Central Valley Regional Water Quality Control Board

NOTICE OF VIOLATION, 3 SEPTEMBER 2014 INSPECTION REPORT, RECOLOGY HAY ROAD, SOLANO COUNTY

INSPECTION REPORT

DISCHARGER: Recology Hay Road
LOCATION & COUNTY: 6426 Hay Road, Vacaville, Solano County
CONTACT(S): Bryan Clarkson, Group Environmental Manager, Recology
INSPECTION DATE: 3 September 2014
INSPECTED BY: Andrew Altevogt, Howard Hold, Mary Boyd, and Marty Hartzell with the Central Valley Regional Water Quality Control Board (Water Board)
ACCOMPANIED BY: Paul Yamamoto (Group Vice President, Recology), Bryan Clarkson Group Environmental Manager, Recology), Chris Taylor (landfill manager, Recology Hay Road), and Tim Daleiden (Engineering and Operations Manager, Recology)

Photograph 1

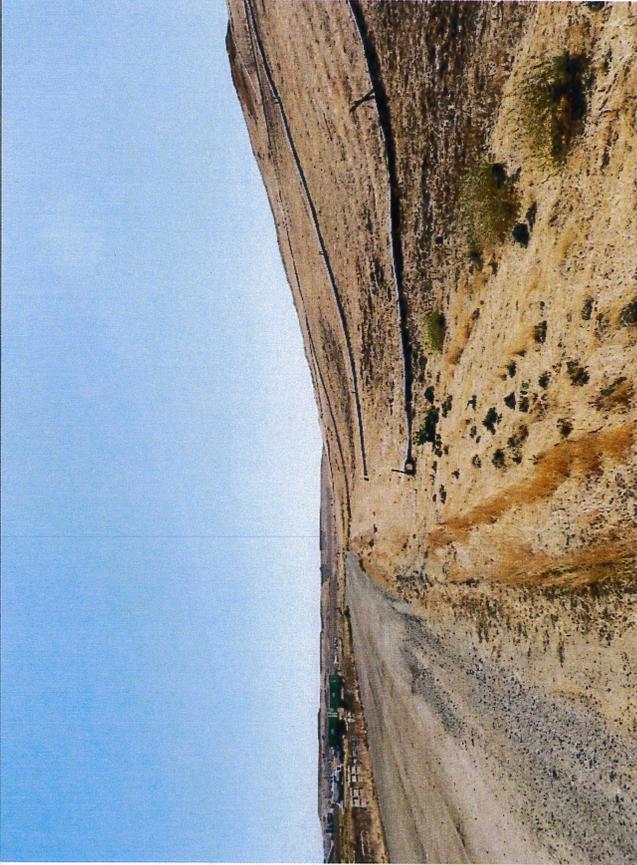
Looking east at the base of Disposal Module (DM) 2.2. This picture shows the downspouts designed to manage runoff from the slope. As constructed, this structure does not comply with Title 27 Section 20365(a) which states: *Units and their respective containment structures shall be designed and constructed to limit, to the greatest extent possible, ponding, infiltration, inundation, erosion, slope failure, washout, and overtopping under the precipitation conditions specified in Table 4.1 (of this article) for each class of waste management unit (Unit).*

As shown in this photograph, there are no runoff ditches at the toe of the downspout. Rain water has nowhere to move to, rather it ponds adjacent to the slope. The Discharger must enhance their runoff channels as outlined in the WDRs and Title 27.

Photograph2

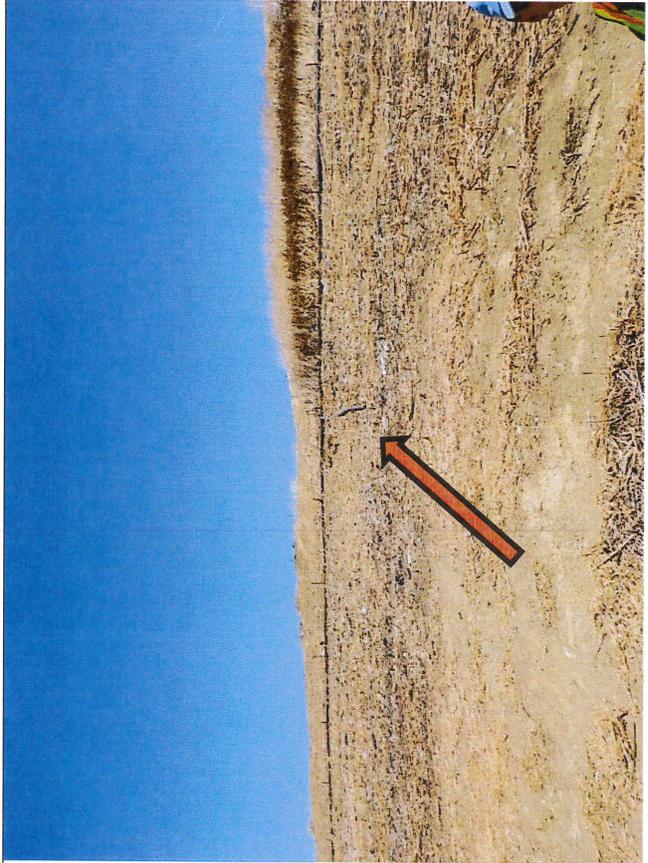
View looking up the southern side slope of DM-2.2, which shows a downspout terminating midway down the slope. In addition this slope needs to be prepared for the winter rains. Currently there is no control on this slope to prevent sheet flow of turbid water.

Photograph 3

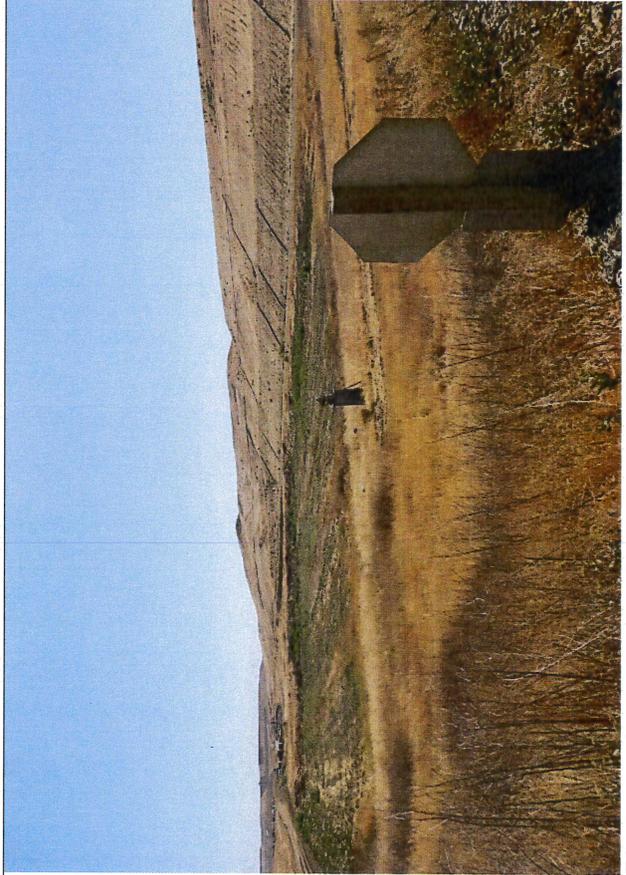
View of the southern side slope at DM-2.2 showing exposed waste. The interim cover appears to be insufficient at this module.

Photograph 7

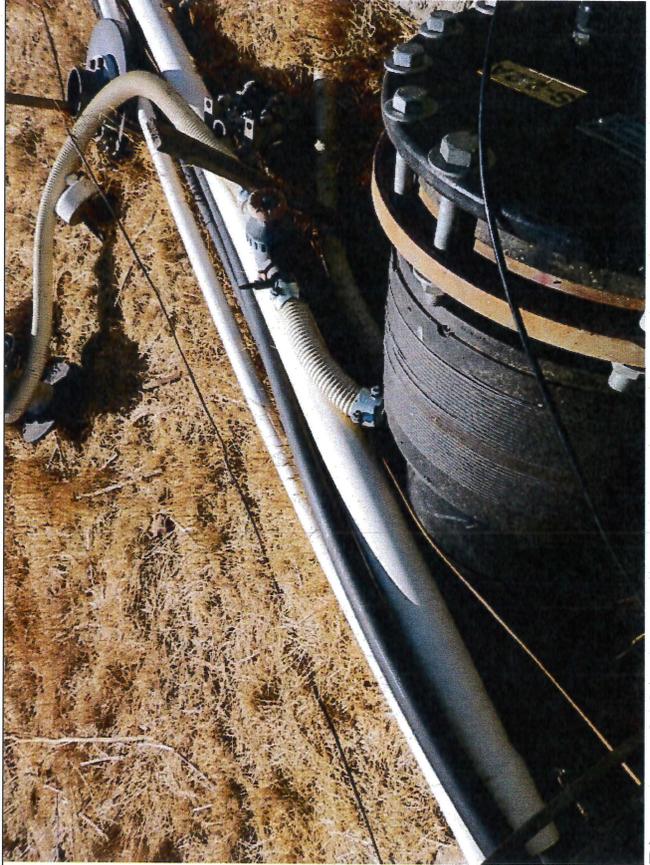
Pictured here are sumps S-2.2A (Leachate sump) and the Pan Lysimeter PLS 2.2A. The leachate sump is the pipe on top. The clear flexible line branching off the side of the S-2.2A is the gas extraction system. The Discharger pumps water from the pan lysimeter into the LCRS sump rather than into an above ground tank. Discharge to the LCRS without approval in the WDRs is a violation of Construction Specification D.6.

Photograph 10

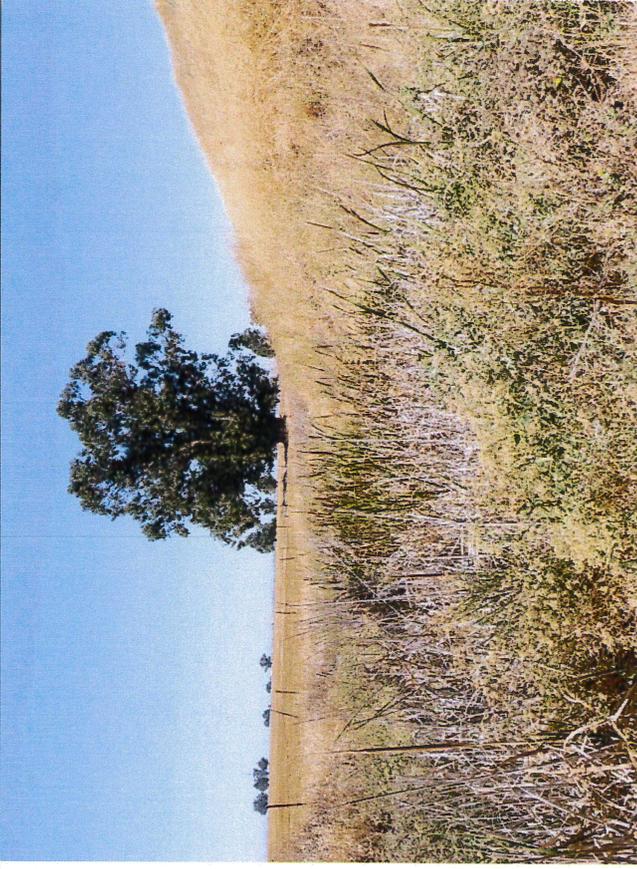
Monitoring well G-11 is not locked and the well expansion cap is not properly placed on the well. This should be corrected immediately.

Photograph 12

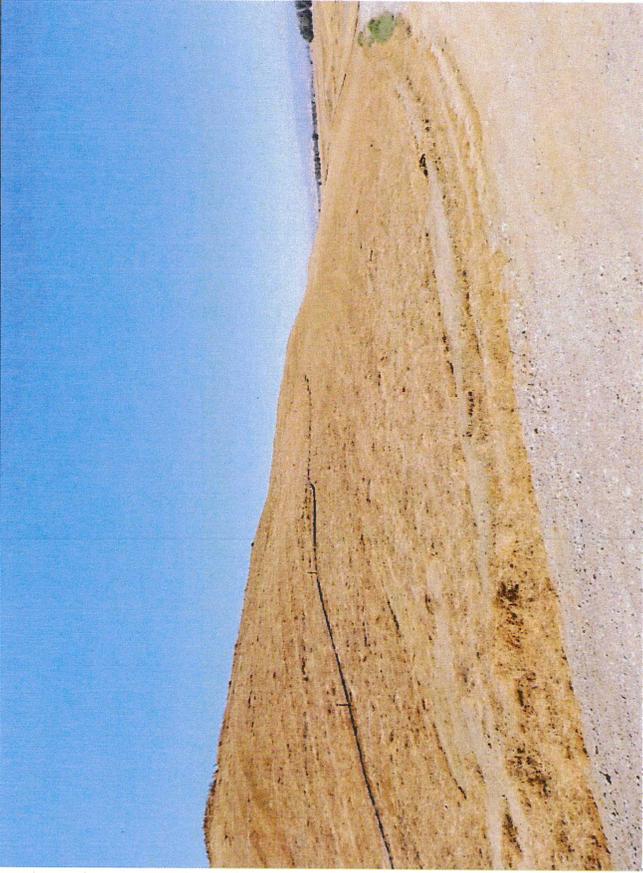
At the base of Unit DM 2.2 there is an area under visqueen plastic. When staff asked the Discharger what this was, they responded a "leachate seep". It was unclear how long this area has been under plastic. The Discharger must address this in the forthcoming winterization plan.

Photograph 13

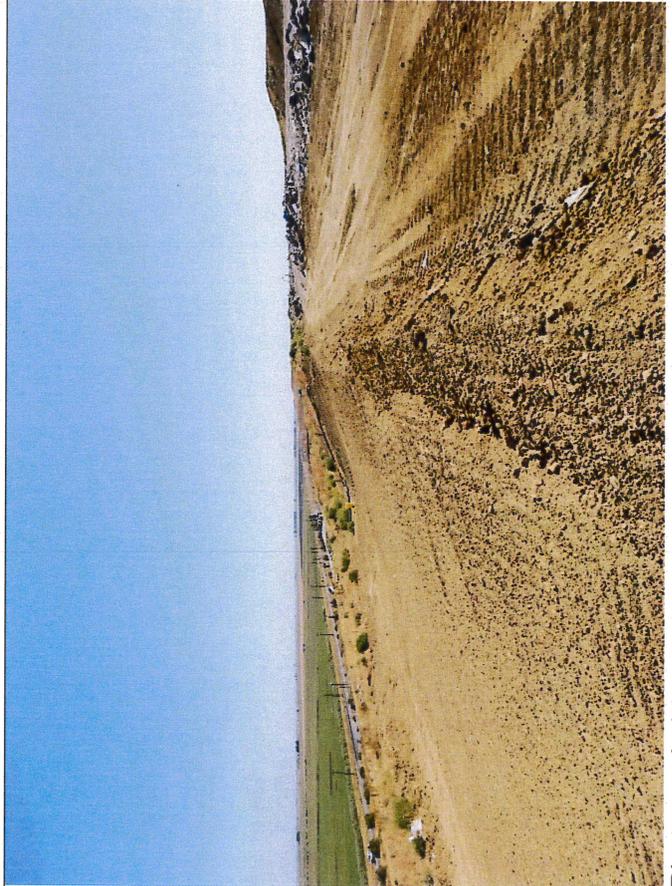
Looking west along the north face of DM-11. There are no runoff ditches installed to move water off this slope.

Photograph 17

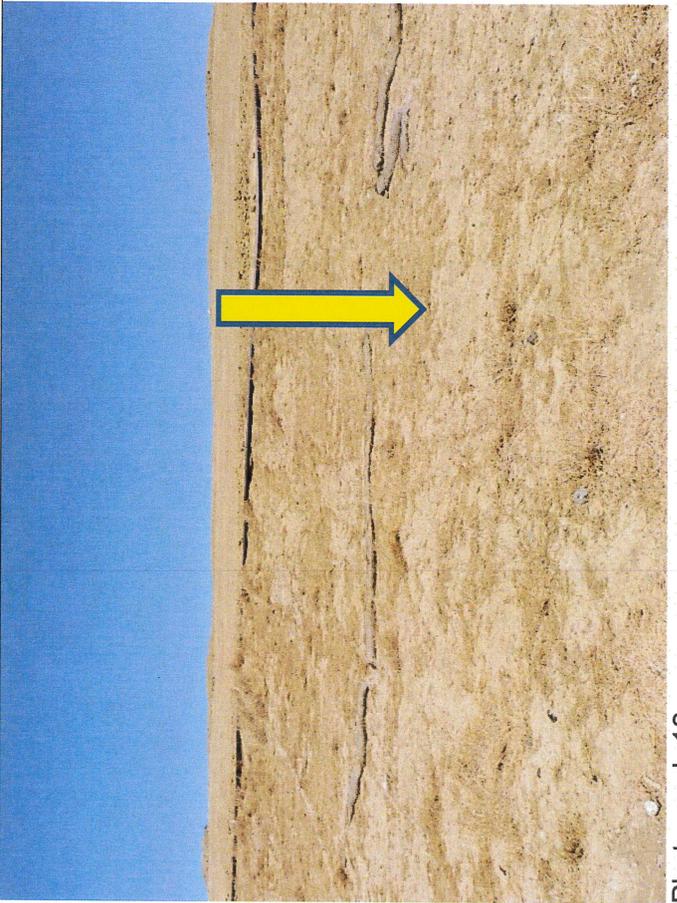
Rill formation on DM-3.3. View from the south bench, looking up the slope. These slopes show evidence of rills, which form during runoff of rainwater. The rills are located up-slope from an erosion gully shown in the next photograph. Rill and gully formation are an indication of inadequate runoff controls.

Photograph 19

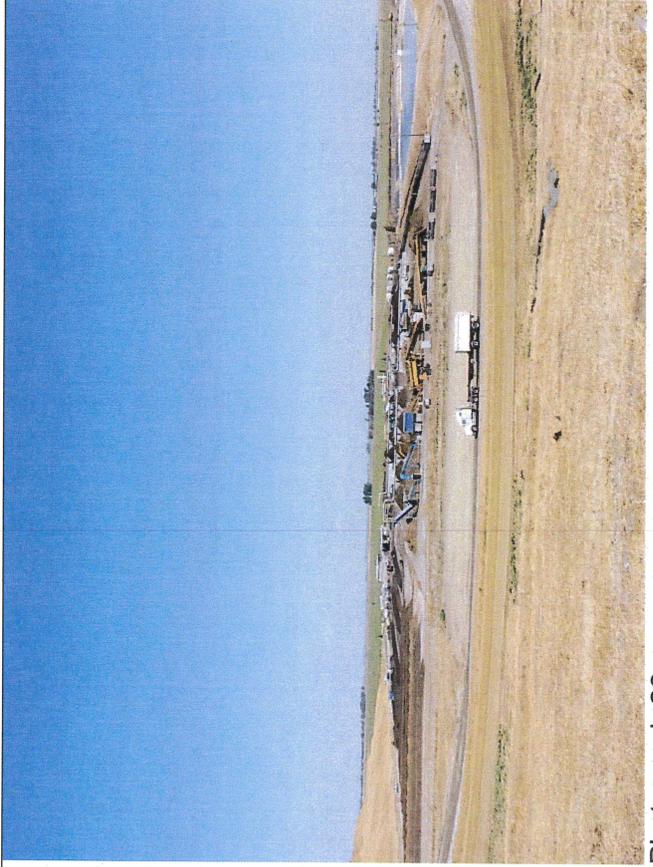
View of plastic sheeting which is partially covering erosion at the bench of the DM-3.3 side slope. This gully may have been formed from ponding of runoff rainwater from the DM-3.3 side slope, which was likely followed by overtopping of the ponded area and the subsequent erosion and gully.

Photograph 22

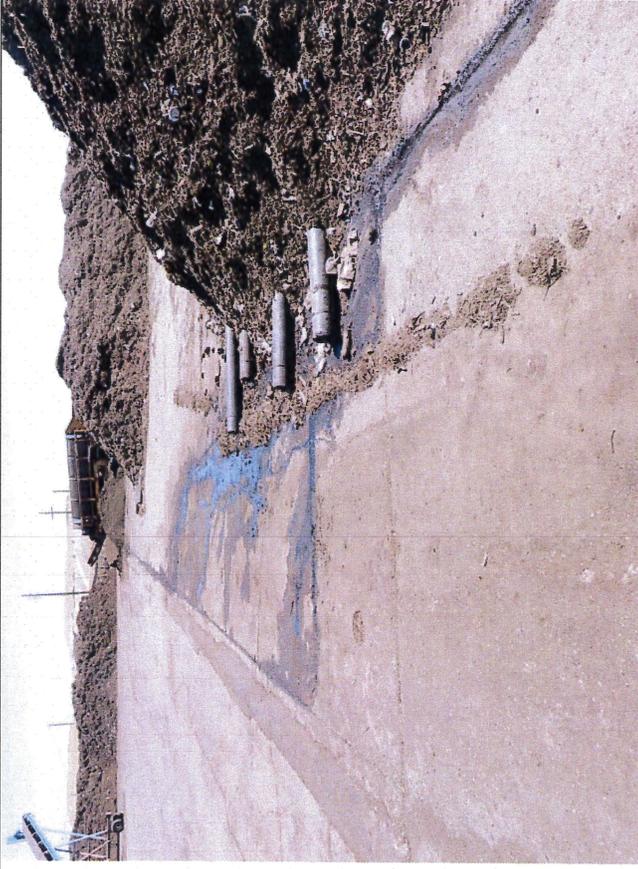
Compost leachate generated during the composting process. The windrow to the right is covered under a "Bio-Filter". No "Ag-Bags" were in use at the time of the inspection. The arrow points to a collection sump. Note the debris in the sump that may reduce the efficiency of the sump.

Photograph 23

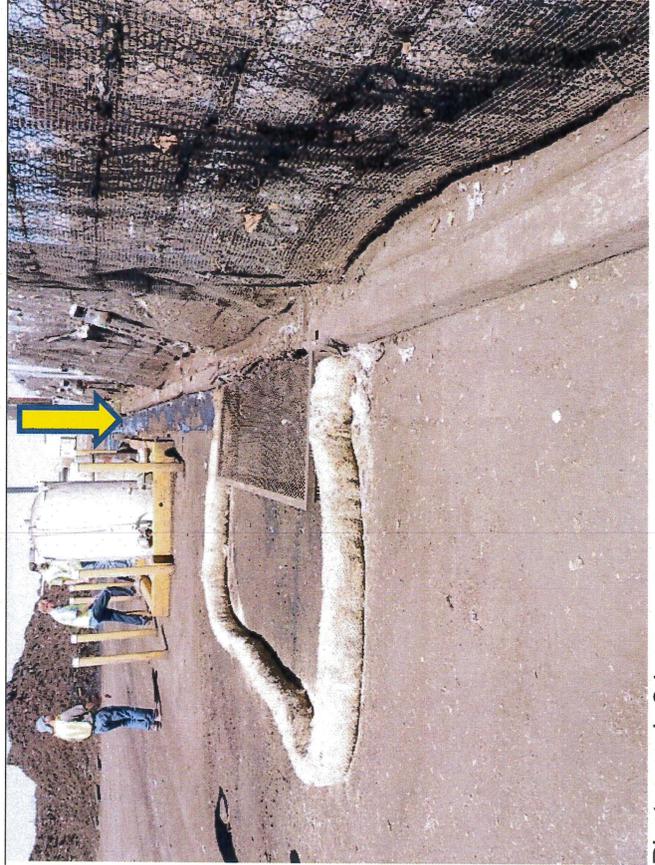
View of food waste composting operations and leachate runoff. Leachate drains across the surface and through channel drains to a collection drainage ditch prior to discharge into the ponds. Currently, the facility is using a static pile system, which does not comply with WDRs requirement for an in-vessel system.

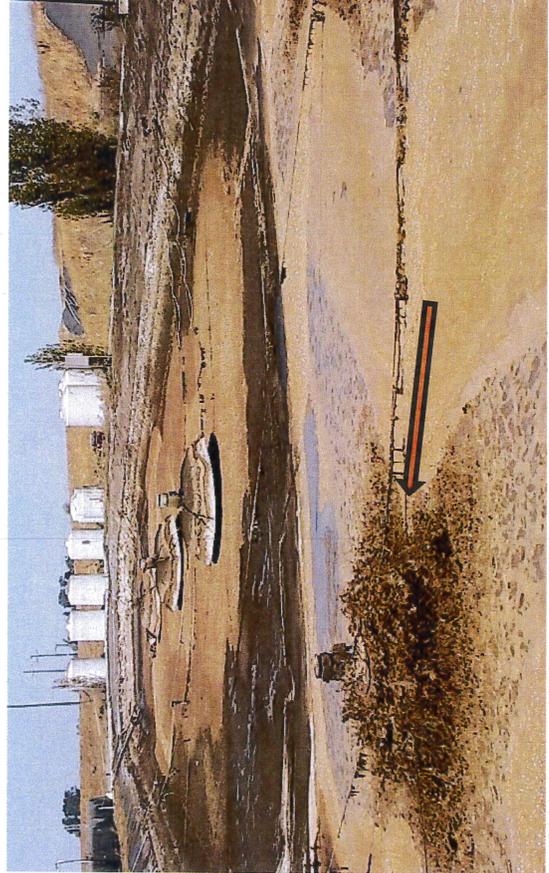
View of the low-flow leachate pond for the food waste composting operations. The arrow points to a typical aerator for this pond, which the Discharger installed to mitigate odor problems associated with the pond. Liquids are pumped out of the pond to an adjacent high-flow pond. The process of pumping liquids out of the low-flow pond and over to the high-flow pond does not comply with the WDRs. Only one of four aerators was operating at the time of the inspection.

Photograph 27

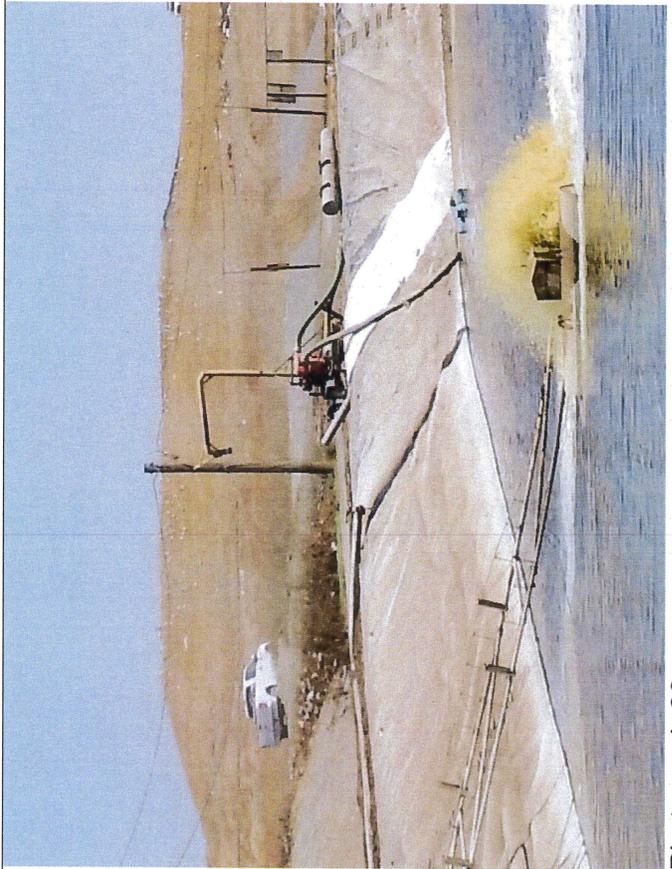
High-flow pond. View of the high-flow pond from the south-west side looking north. This pond contains leachate, which does not comply with the WDRs.
